# Foam Bracket Installation Change SB-147

Subject: Change to 3.3, 5.0, and 6.5 Foam Pump Installation

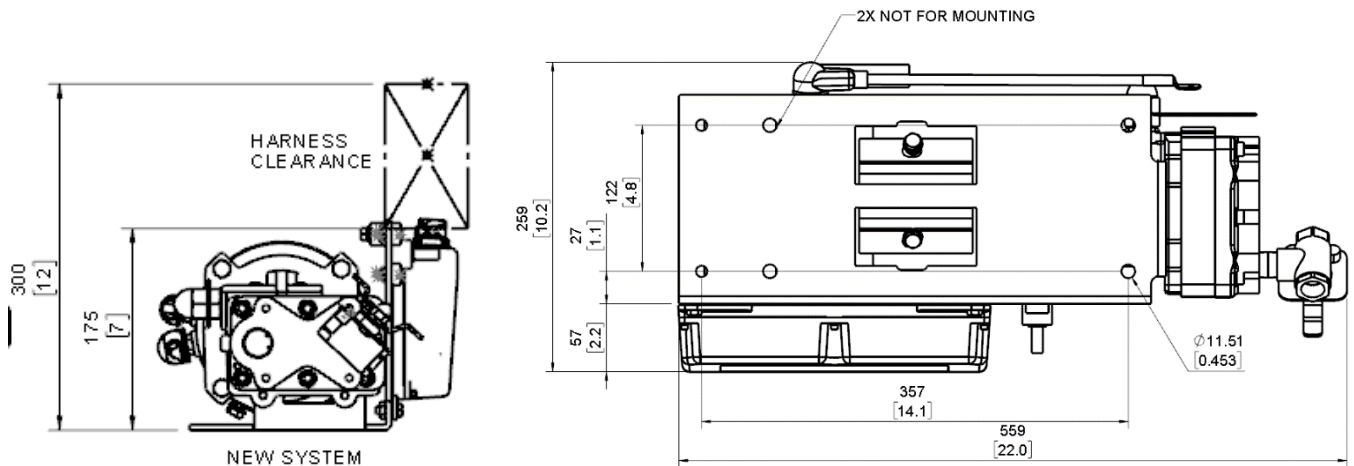
Foam systems 3.3, 5.0, and 6.5 have been updated with the new motor driver bracket effective immediately:

The motor driver is now mounted on the other side so you can access the bypass and check the operation of the motor driver easily. It has also made checking the power and ground to the motor easier. Installation may need to be shifted 3" to prevent interference. It should also be noted that some room (3-4 inches) should be left above the foam pump for the harness and the fan on the back of the motor should have an additional 3-4 inches of clearance (minimum of 1-2 inches) for adequate air flow to cool the motor.
